SAN FRANCISCO PLANNING DEPARTMENT

Executive Summary Adoption Hearing Western Shoreline Area Plan Amendment HEARING DATE: JUNE 8TH, 2017

Date: May 24, 2017
Case No.: **2014.2110CWP**
Staff Contact: Maggie Wenger– (415) 575-9126
Maggie.wenger@sfgov.org
Reviewed by: Chris Kern – (415) 575-9037
Chris.Kern@sfgov.org
Recommendation: Recommend Approval

Figure 3. Ocean Beach Master Plan Key Move 2, proposed removal of the Great Highway and parking lots between Sloat Boulevard and Skyline Drive with low profile protection for the Lake Merced Tunnel and other wastewater infrastructure. Graphic Credit: SPUR, 2012.

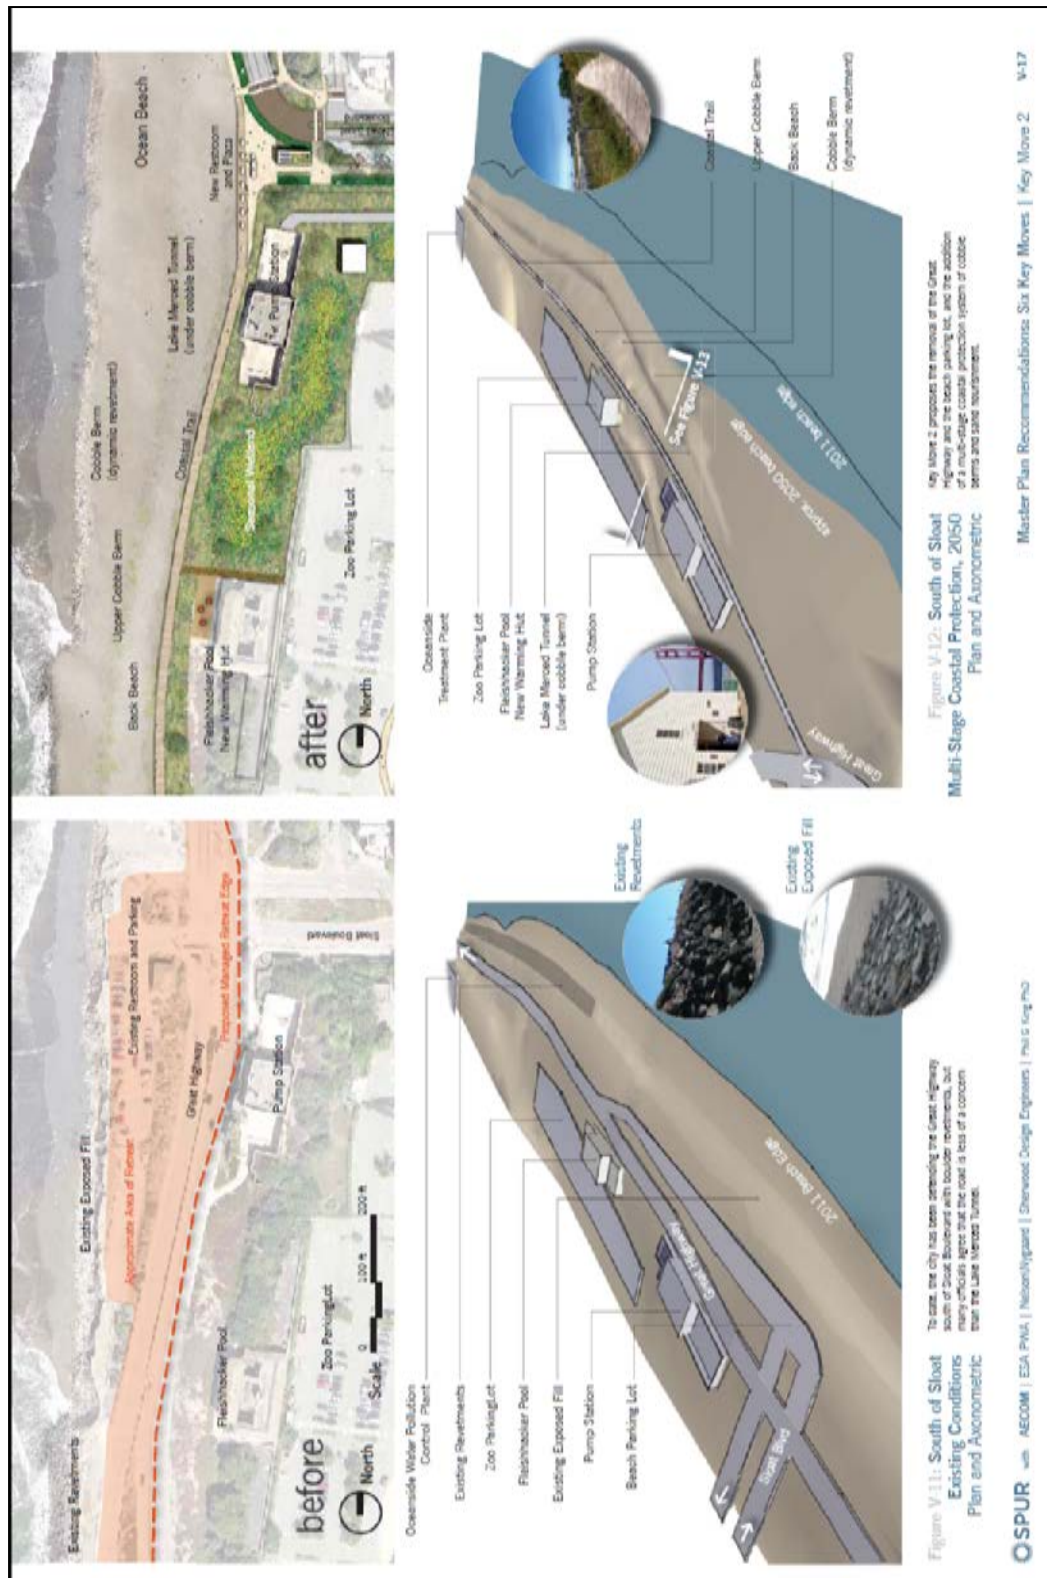
The article has a picture of erosion at Ocean Beach that they say will endanger the Lake Merced tunnel and that the proposed amendments to the Local Coastal Plan will address erosion, coastal protection and sea level rise. Their solution calls for removal of all armoring at south Ocean Beach, allowing the ocean to erode the natural land there. The fact is that there has been no erosion at the two rock revetments in the area. The only erosion has been to the bluffs that are protected only by the artificial cobblestone berm formed from the concrete rubble that has fallen from the old roadway lying between the revetments. That same bluff suffered additional erosion from the top down after the asphalt was removed prior to this winter. The Plan calls for a cobblestone berm to be placed adjacent to the Wastewater Treatment Plant for protection after the rock revetments have been removed. Interestingly, the Plan itself contains the information that cobblestone berms do not provide complete protection from erosion by wave action and the evidence is at the beach today. In effect, implementation of the Plan will mean that the Wastewater Treatment Plant will be flooded by the sea decades sooner than if the rock revetments were to remain in place.

Holl-4	<p>Regarding the Ocean Beach Master Plan's proposed actions south of Sloat Boulevard:</p> <p>"Their solution calls for removal of all armoring at south Ocean Beach, allowing the ocean to erode the natural land there."</p>	<p>It is true that implementation of the Ocean Beach Master Plan would remove debris, rubble, and armoring that is currently protecting the backshore area along some sections of south Ocean Beach; however, much of this land is not "natural land" and is instead composed of rubble and fill that was placed there over the course of the 21st century. It is this artificial fill that has suffered erosion over many decades. While some armoring would be removed, a new coastal protection structure would be built adjacent to and overtop of the Lake Merced Tunnel to protect it from wave and erosion damage. This hard protective structure would be augmented by a cobble berm and regular sand nourishment of the fronting beach and recontouring of the shoreline to create a natural coastal system that is more resilient to coastal storm attack than the existing shoreline.</p>
